# Port Authority of New York and New Jersey Summary of Public Comments on Proposed 2017-2026 Capital Plan

February 16, 2017

# Restoring the George: Exterior fencing replaced for increased safety

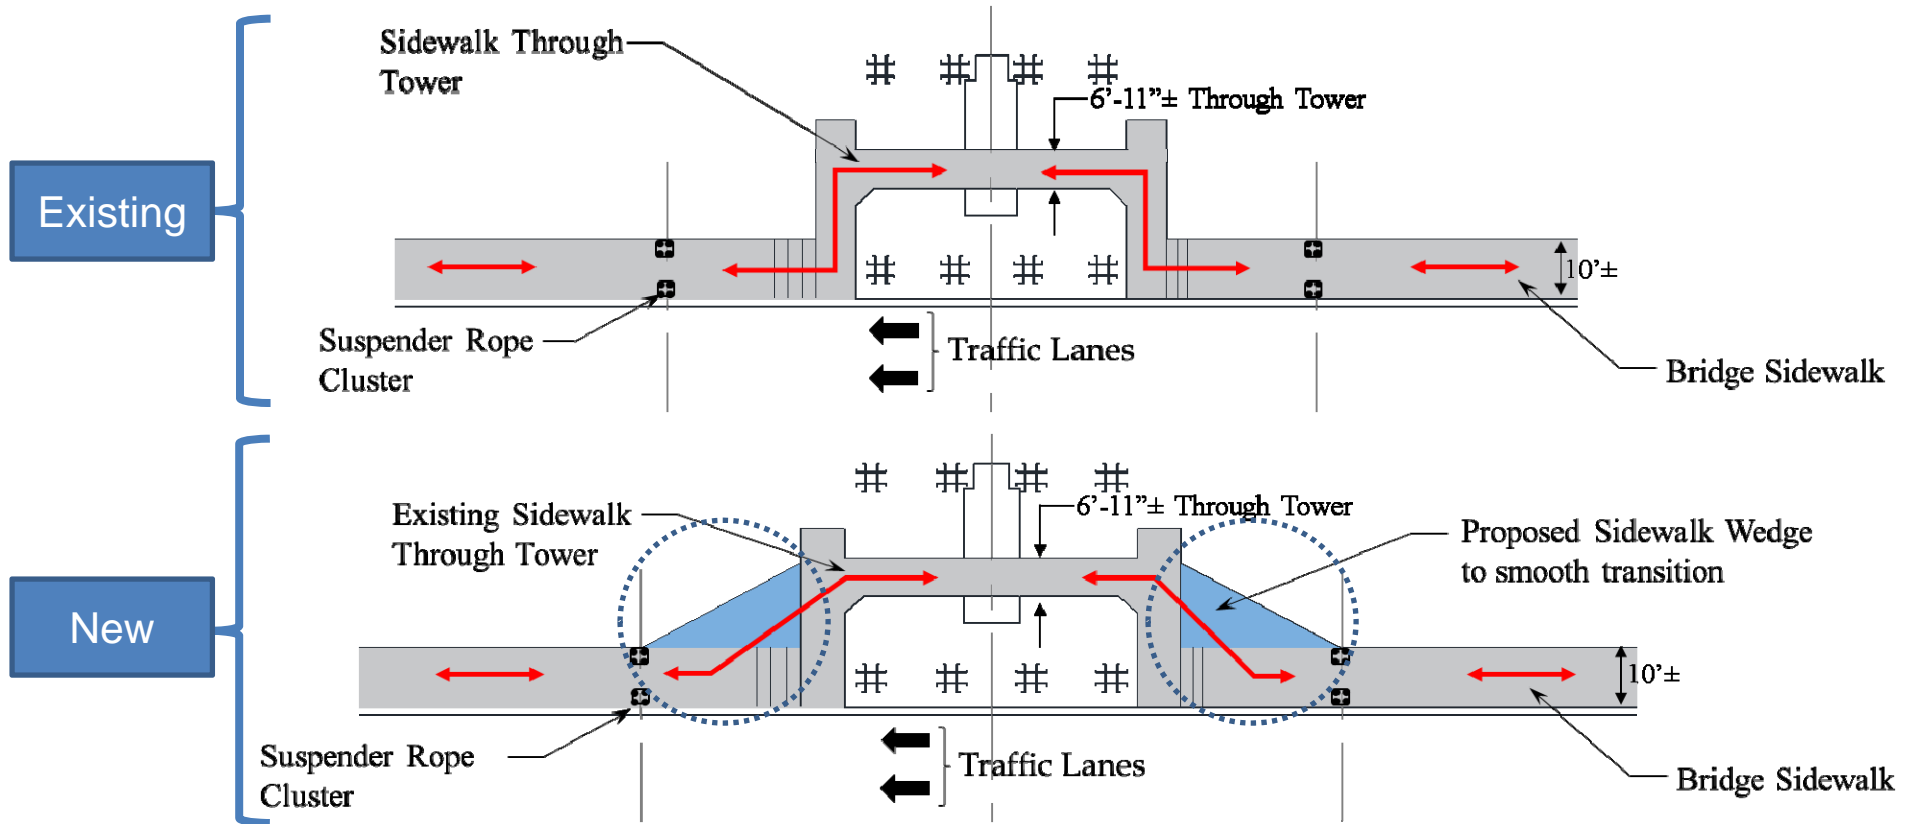
Partial height fence at the approach ramps and main span

New 11' high safety fence at the main span of the bridge; sidewalk access ramps will be 9' high; vehicular side rail will also be replaced
